**TECHNICAL BULLETIN**

Customer Intermittently Locked Out Of  
Vehicle After Closing Door –  
Install New Door Handle Damper

MODEL 2001 MY-ON  
S-TYPE  
VIN M23023-ON

Remove and destroy Bulletin S501-23, dated 01/04.  
Replace with this Bulletin.  
Revisions are marked with a bar and in **bold text**.

ILLUSTRATION 1

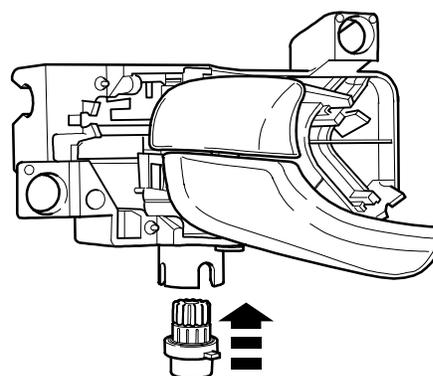
Some 2001 MY-ON S-TYPE vehicles **from the above VIN**, customers may have a concern of intermittently being locked out of the vehicle after closing a front door. This problem may be caused by the interior handle springing back and activating the central locking. To address this concern, a new damper can be installed to both front interior door handles.

2. Install and fully seat the new damper into the interior door handle housing, ensure damper is located with a definite click (Illustration 1).
